Contract #: 04-0120F4Cty: SF/ALA Rte: 80 PM: 13.2/13.9File #: 69.25B**QUALITY ASSURANCE -- NON-CONFORMANCE REPORT****Location:** Changxing Island, Shanghai, P.R. China**Report No:** NCR-000538**Prime Contractor:** American Bridge/Fluor Enterprises, a JV**Date:** 16-Dec-2009**Submitting Contractor:** Zhenhua Port Machinery Company, Ltd (ZPMC), Changxing Island**NCR #:** ZPMC-0511**Type of problem:**

Reference Description: Base Metal Repairs without Engineer's Approval, Segment 7CW**Description of Non-Conformance:**

To:	AMERICAN BRIDGE/FLUOR, A JV 375 BURMA ROAD OAKLAND CA 95607	Date:	24-Dec-2009
Dear:	Mr. Charles Kanapicki	Contract No:	04-0120F4 04-SF-80-13.2 / 13.9
Attention:	Mr. Thomas Nilsson Project/Fabrication Manager	Job Name:	SAS Superstructure
Subject:	NCR No. ZPMC-0511	Document No:	05.03.06-000499

Subject: NCR No. ZPMC-0511

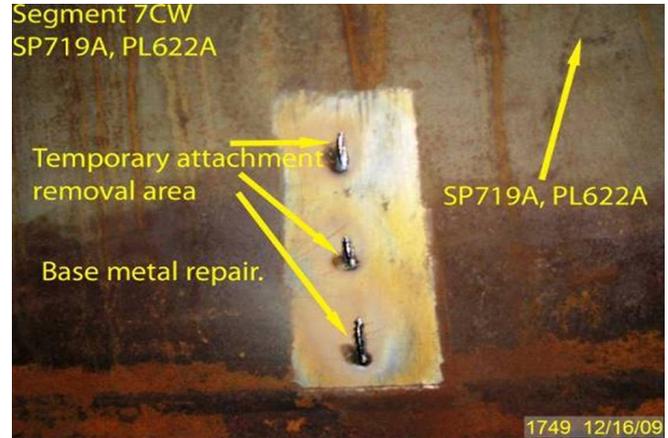
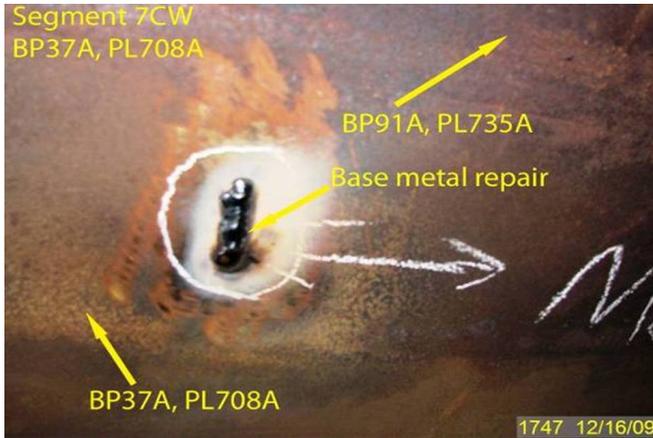
During the Quality Assurance random in-process visual inspection of Segment 7CW, this Quality Assurance Inspector (QA) discovered the following issue:

-Base metal repairs being performed in way of temporary attachment removal areas on the bottom and side plates without the prior approval of the engineer.

- SP126A, Plate number-PL250A
- SP153A, Plate Number-PL533A
- SP719A, Plate Number-PL622A
- SP481A, Plate Number-PL621A
- SP440A, Plate Number-PL1279A
- BP91A, Plate Number-PL735A
- BP37A, Plate Number-PL708A
- BP145A, Plate Number-PL789A
- The material is A709 Grade 345 non SPCM

Standard Specifications (99) section 8-3.01: "The Engineer shall be notified immediately in writing when welding problems, deficiencies, base metal repairs, or any other type of repairs not submitted in the WQCP are discovered and also of the proposed repair procedures to correct them. For requests to perform repairs, The contractor shall include an engineering evaluation of the proposed repair."

ZPMC Welding Quality Control Plan, Section 9.2.1.2: "Prior approval of the Engineer shall be obtained for repairs to base metal other than what was identified in Section 9.2.1.1 of this manual and the repair of all other cracks."

AWS D1.5/2002, Section 3.7.4: "Prior approval of the Engineer shall be obtained for repairs to base metal."

Submit a repair procedure to the engineer for approval. A response for the resolution of this issue is expected within 7 days.

CT/ABF and ZPMC have established a procedure in which non-SPCM temporary attachment removal base metal repairs are performed in accordance with procedure TA100 supplemented with a WRR that contains a pre-established weld repair disposition as agreed to by CT, ABF and ZPMC. The WRR will reference the location and number of areas to be weld repaired. The QA inspector will be notified prior to weld repairs for the purposes of performing QA verification if of the areas prepared for welding. The QA inspector will also be notified when the finished weld repair has been accepted by ZPMC and ABF for QA verification. The WRR and applicable weld procedure must be available on site during the welding operation.

The documentation submitted by the contractor has been reviewed by the Enigneer and is found to be acceptable.

In accordance with the Fabrication Procedures, the Contractor is not required to obtain the Engineer's approval prior to performing base metal repairs resulting from temporary attachment removal on non-SPCM material. Further discussions have led to a mutual agreement that WRRs will be used to track the locations of such base metal repairs on non-SPCM members.

Reference Description: Base Metal Repair on Segment 10AW Deck Panel without Engineer's Approval

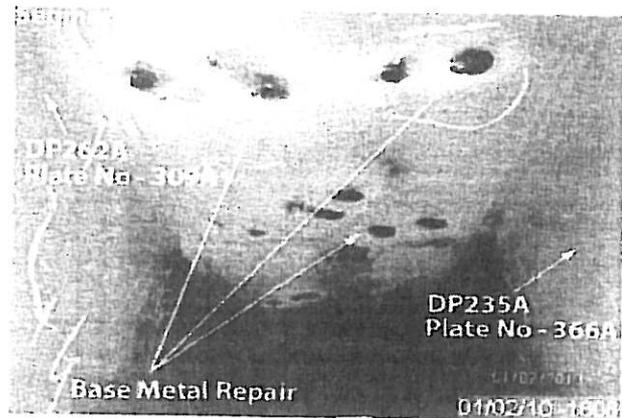
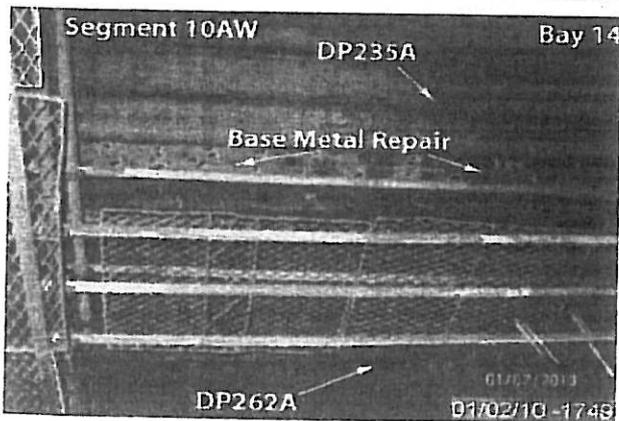
During the Quality Assurance (QA) random in-process visual inspection of Orthotropic Box Girder (OBG) Segment 10AW, this QA inspector discovered the following issue:
 -Base metal repairs were being performed that were caused by the removal of temporary attachments on two (2) Deck Plates, without the prior approval of the Engineer.
 -The Deck Panels are identified as: DP262A (PL309A) and DP235A (PL366A)
 -The weld splice joining Deck Panels DP262A and DP235A are identified as: SEG059*007
 -The steel deck material is A709 Grade 345 non SPCM.

Caltrans Special Provision Section 8-3.01: "The Engineer shall be notified immediately in writing when welding problems, deficiencies, base metal repairs, or any other type of repairs not submitted in the WQCP are discovered and also of the proposed repair procedures to correct them. For requests to perform repairs, the contractor shall include an engineering evaluation of the proposed repair."

ZPMC Welding Quality Control Plan, Section 9.2.1.2: "Prior approval of the Engineer shall be obtained for repairs to base metal other than what was identified in Section 9.2.1.1 of this manual and the repair of all other cracks."

AWS D1.5/2002, Section 3.7.4: "Prior approval of the Engineer shall be obtained for repairs to base metal."

Propose a resolution for the identified non-conformance with revised procedures to prevent future occurrences. Notify the engineer prior to starting base metal repair. A response for the resolution of this issue is expected within 7 days.

Reference Description: ZPMC performed base metal repairs without the Engineer's approval in Segment 6AW Deck Plate

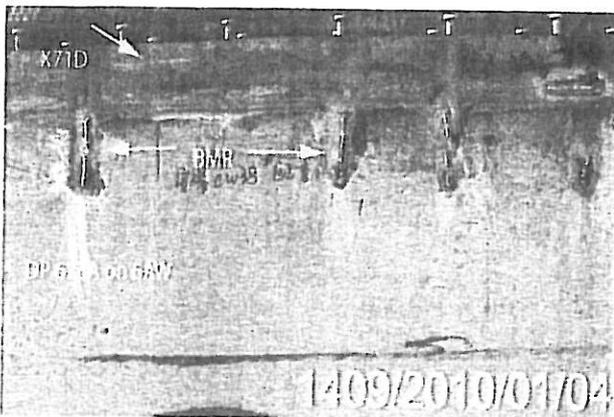
- Base metal repairs (BMR) were being performed that were discovered from the removal of temporary attachments on a Deck Plate, without the prior approval of the Engineer.
- There are a total of 22 locations of these base metal repairs.
- The approximate length of the BMR is random. They are running adjacent to the X71D Counter Weight attachment plate.
- The Counterweight side of Deck Plate is identified as: DP623A
- The Counterweight attachment plate is identified as X71D.
- The material is A709M Grade 345 non SPCM.
- Deck Plate is located on top of Segment 6AW in the Trial Assembly area.

Special Provisions Section 8-3.01: "The Engineer shall be notified immediately in writing when welding problems, deficiencies, base metal repairs, or any other type of repairs not submitted in the WQCP are discovered and also of the proposed repair procedures to correct them. For requests to perform repairs, the contractor shall include an engineering evaluation of the proposed repair."

ZPMC Welding Quality Control Plan, Section 9.2.1.2: "Prior approval of the Engineer shall be obtained for repairs to base metal other than what was identified in Section 9.2.1.1 of this manual and the repair of all other cracks."

AWS D1.5/2002, Section 3.7.4: "Prior approval of the Engineer shall be obtained for repairs to base metal."

Propose a resolution for the identified non-conformance with revised procedures to prevent future occurrences. Do not initiate base metal repair until the engineer is notified. A response for the resolution of this issue is expected within 7 days.

Reference Description: Base Metal Repairs without Engineer's Approval, Segment 7CW

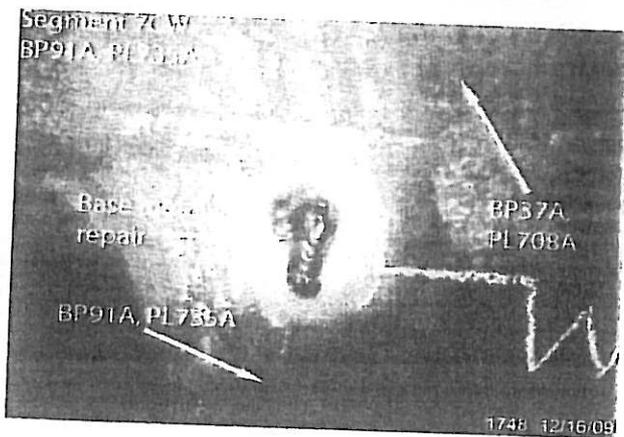
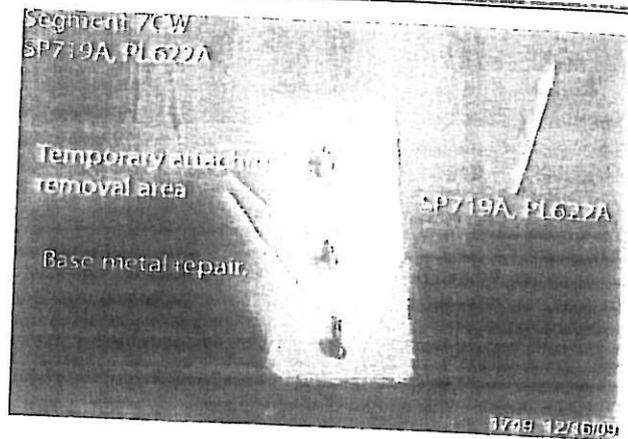
-Base metal repairs being performed in way of temporary attachment removal areas on the bottom and side plates without the prior approval of the engineer.

-BP91A, Plate Number-PL735A

-BP37A, Plate Number-PL708A

-BP145A, Plate Number-PL789A

Standard Specifications (99) section 8-3.01: "The Engineer shall be notified immediately in writing when welding problems, deficiencies, base metal repairs, or any other type of repairs not submitted in the WQCP are discovered and also of the proposed repair procedures to correct them. For requests to perform repairs, The contractor shall include an engineering evaluation of the proposed repair."
